INDESIT company

WT40EX

F026865

Notices

FIG. 1

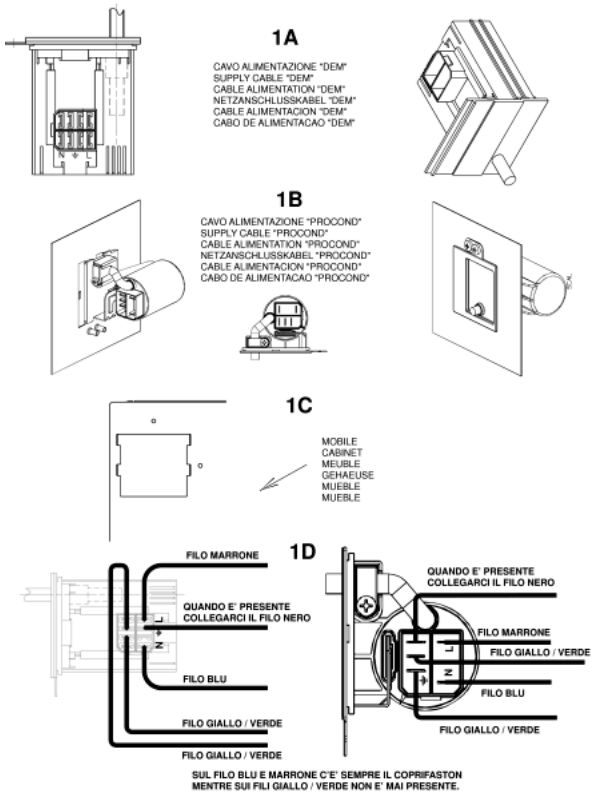
To use premodified wirings on modified products perform the connection to the terminal block of the new cable as shown in fig. 1 - 1D.
The wiring diagrams indicated in the Documentation remain the same.

N1040309FIG1

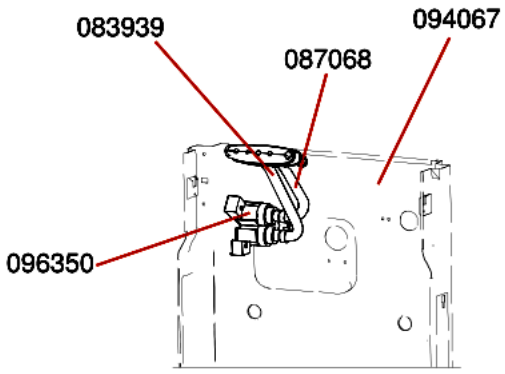
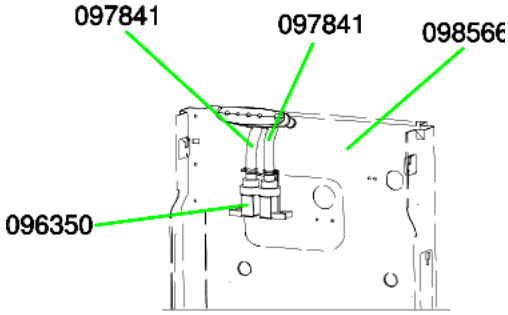
From serial no. 30912.0001, the system used for fixing the loading solenoid valve (spare part code 096350) to the rear panel has been modified on Top Loading washing machines, rotating its position by 90°.
The solenoid valve (spare part code 096350) has been modified with the 45° rotation of a coil; the Replacements Warehouse will continue to manage this part with the same code. When replacing on premodification machines, fit the coils as shown in figure N1040309FIG3-1 and on modified machines, as shown in figure N1040309FIG3-2; to rotate the coil, lift it using a screwdriver and then refit according to the inserts on the plastic.

Replacement codes of the parts affected by this modification (see figure N1040309FIG1):

FIG1 A - PREMODIFICATION STRUCTURE
solenoid valve tube/distributor assembly: premodification 083939;
solenoid valve tube/distributor assembly: premodification 087068;
rear panel: premodification 094067.
FIG1 B - NEW STRUCTURE
solenoid valve tube/distributor assembly: new 097841;
solenoid valve tube/distributor assembly: new 097841;
rear panel: new 098566.

Premodification panels will be managed by the Replacements Warehouse while stocks last; when replacing with new ones on premodification appliances the new tubes must also also be used.
When using the new panels on appliances before serial no. 30609.0001, fitted with solenoid valve code 083940, rotate the coil 45° and follow the instructions given above for code 096350, paying attention during the wiring phase to keep the cables away from the bowl support spring.

N1040309FIG2

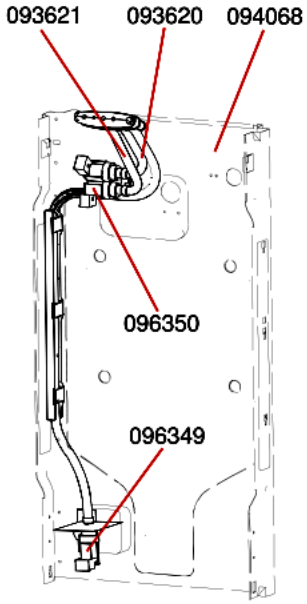
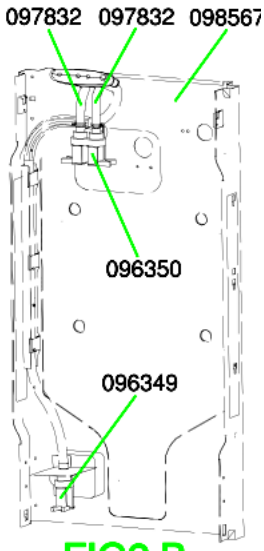
Replacement codes of the parts affected by the modification to WMTL80UK (see figure N1040309FIG2):

FIG2 A - PREMODIFICATION STRUCTURE
solenoid valve tube/distributor assembly: premodification 093620;
solenoid valve tube/distributor assembly: premodification 093621;
rear panel: premodification 094068.
FIG2 B - NEW STRUCTURE
solenoid valve tube/distributor assembly: new 097832;
solenoid valve tube/distributor assembly: new 097832;
rear panel: new 098567.

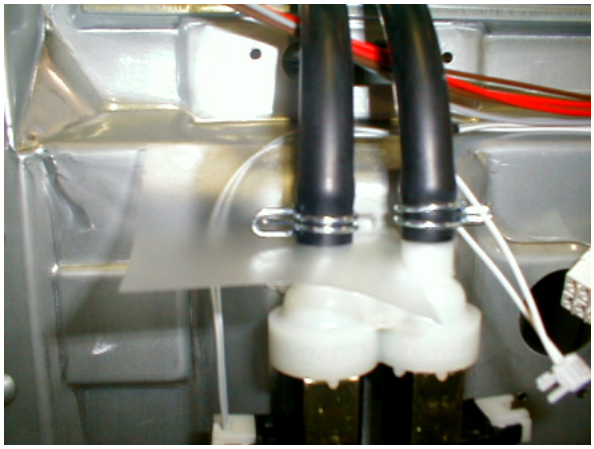
n1040321: Plastic protecion for solenoid valve.

All top-load washing machines produced from September 2003 to February 2004 (from serial no. 30900.0000 to 40300.0000)

have been equipped with a plastic protection Service code 109798 (shown in N1040321FIG1), to prevent water from damaging the solenoid valve and electronic card.

N1040324FIG1

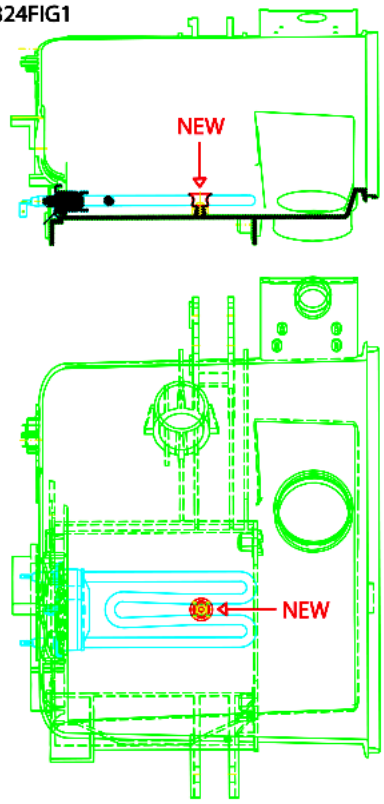
From serial number 40506.0001, the fixing system of the heater to the tank has been modified on all top-load washing machines affected by this note, with the introduction of a metal retainer (image N1040322FIG1 reference NEW) in place of deflector Service code 055322.

The modification has involved both heater and tanks. Given below are the Service codes of the new and old items concerned:

-PLASTIC TANK FOR 600-1000 RPM MACHINES: new 110152, premodification 083805;

-PLASTIC TANK FOR 1200 RPM MACHINES: new 110153, premodification 092023;

-HEATER: new 110148, premodification 083906.
